Detailed Site Plan Departure from Sign Design Standards Steeplechase Business Park

DSP-05044-14
DSDS-24001

STAFF REPORT

SUBJECT: Detailed Site Plan DSP-05044-14
Departure from Sign Design Standards DSDS-24001
Steeplechase Business Park

Figure 2: Freestanding Sign

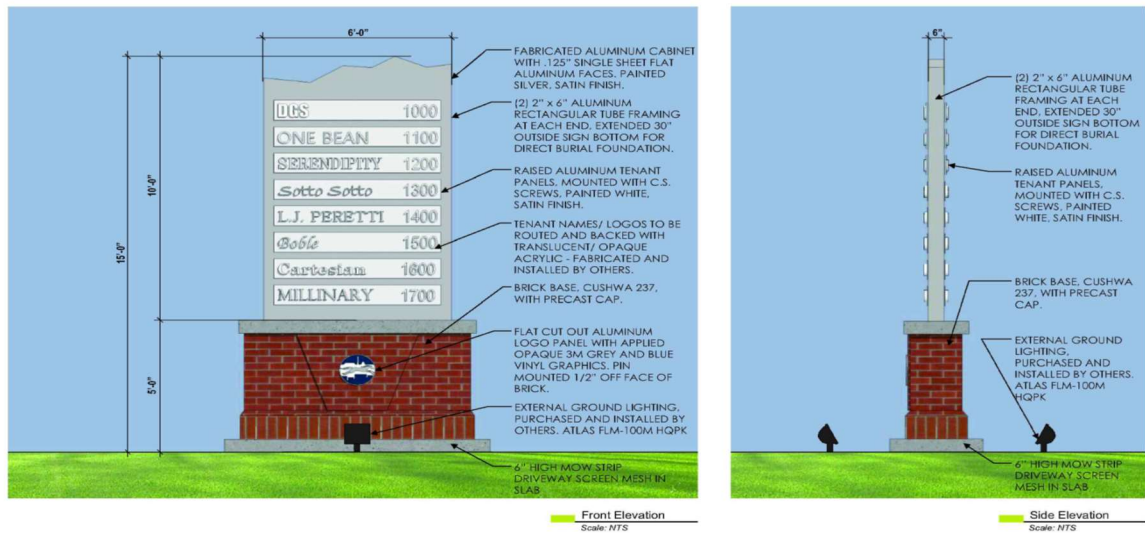
A detail for the freestanding sign is provided with the plan set and proposes a pylon sign to advertise future tenants. The sign will have a brick base with aluminum cabinet and raised tenant panels. The total height of the sign will be 15 feet, with a signage face of approximately 60 square feet. The freestanding sign will be illuminated externally by ground lighting.

Section 27-614 of the prior Zoning Ordinance provides regulations for freestanding signs. The maximum height allowable is 25 feet. The proposed height is 15 feet. The maximum allowable area for the sign is calculated as 1-square-foot of sign area for each 2 lineal feet of street frontage, to a maximum of 200 square feet. The maximum allowed for this project is 173.7 square feet. The DSP proposes 60 square feet and, therefore, is within the allowable square footage.

DETAILED SITE PLAN

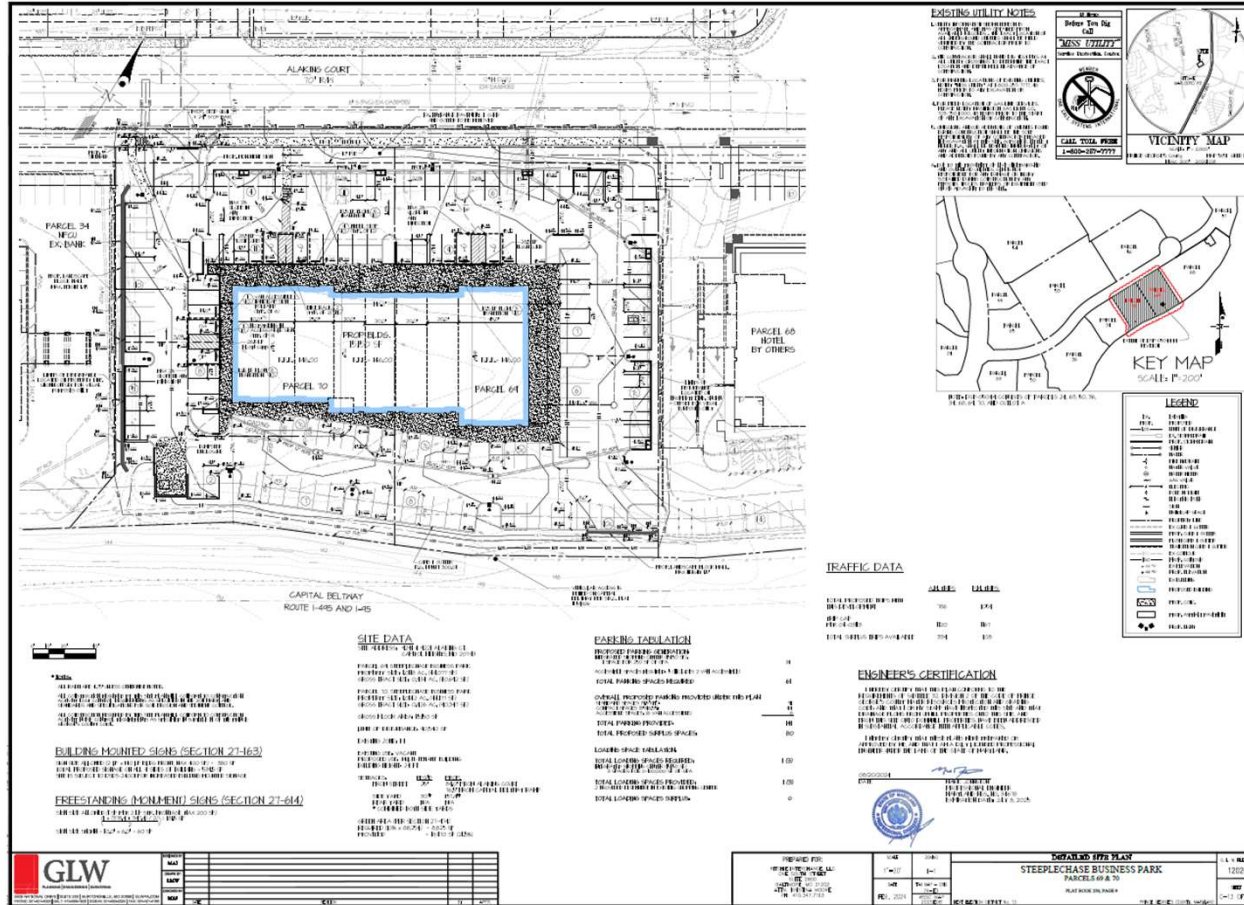
1. Prior to certificate approval of the detailed site plan, the following revisions shall be made, or information shall be provided:
 - a. Add a building height label to the site plan.
 - b. If a fire department connection (FDC) will be provided, the detailed site plan shall show the proposed FDC located on the front, address side of the building. Any FDC must be located within 200 feet of a fire hydrant.
 - c. Updated plan sheets that include pedestrian crosswalks with Americans with Disabilities Act-compliant curb ramps, for all points of vehicle access.
 - d. Provide a general note stating that Departure from Sign Design Standards DSDS-24001 has been approved.
 - e. Add a note indicating that all light fixtures are full cut-off and directed downward to reduce glare and light spill-over.

BUILDING ELEVATIONS AND SIGNAGE

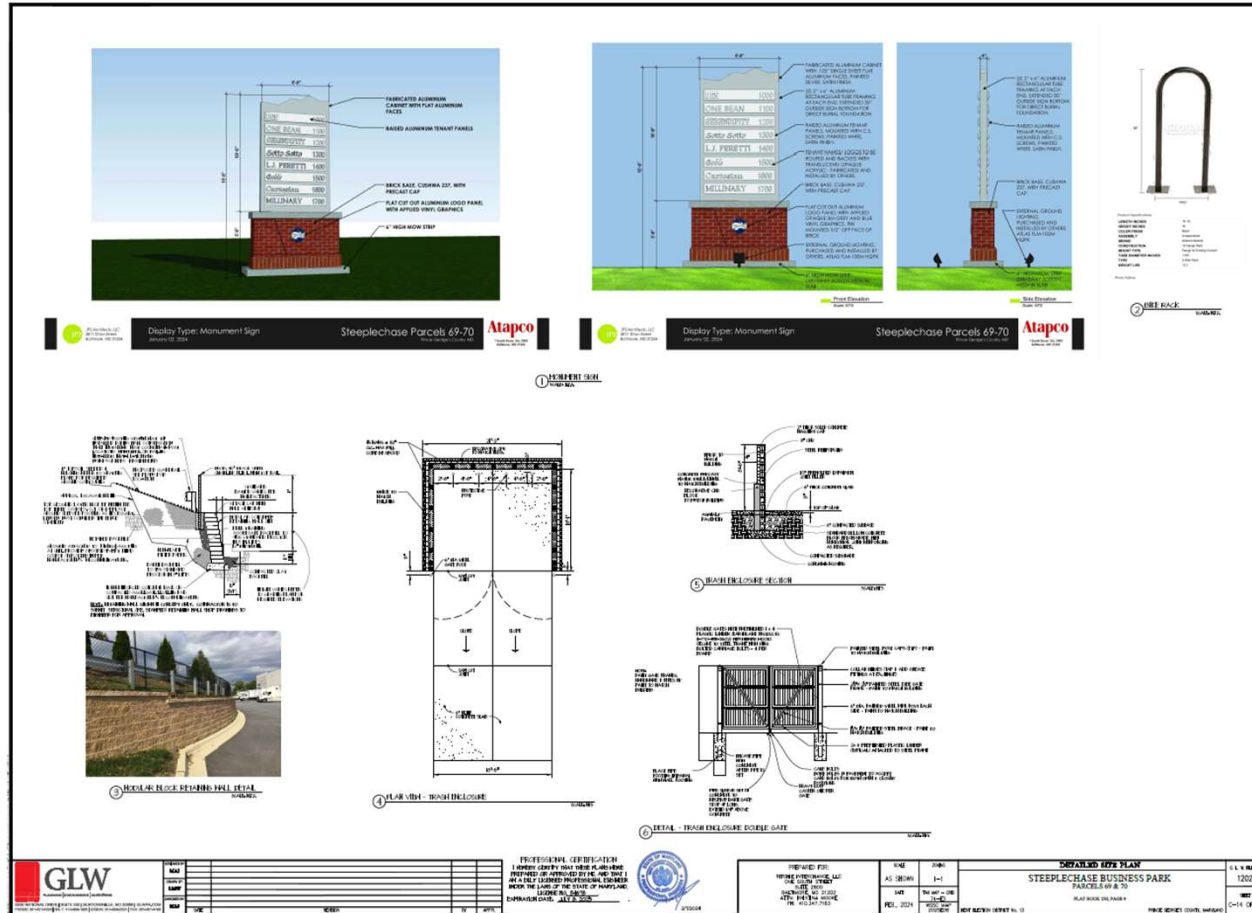
9. Departure from Sign Design Standards DSDS-24001: The applicant is proposing to increase the building-mounted signage for the overall building from the allowed 380 square feet to 537.5 square feet. The applicant has requested a DSDS, in accordance with Section 27-612 of the prior Zoning Ordinance. Section 27-239.01(b)(7)(A) of the prior Zoning Ordinance provides that in order for the Planning Board to grant the departure, it shall make the following findings:

The applicant considers the departure to be the minimum necessary to provide visibility of signs for each tenant from the nearby road frontages and adjacent employment uses. Staff find that the proposed size, design, and location of the signs will be consistent with signage on other buildings and sites within the retail area of Steeplechase Business Park. For these reasons, staff find that the departure is the minimum necessary, given the specific circumstances of the request.

Based on the analysis above, staff recommend that the Planning Board approve DSDS-24001 for the proposed building-mounted signage, which is designed at an appropriate scale for the size and type of development within the existing Steeplechase Business Park.
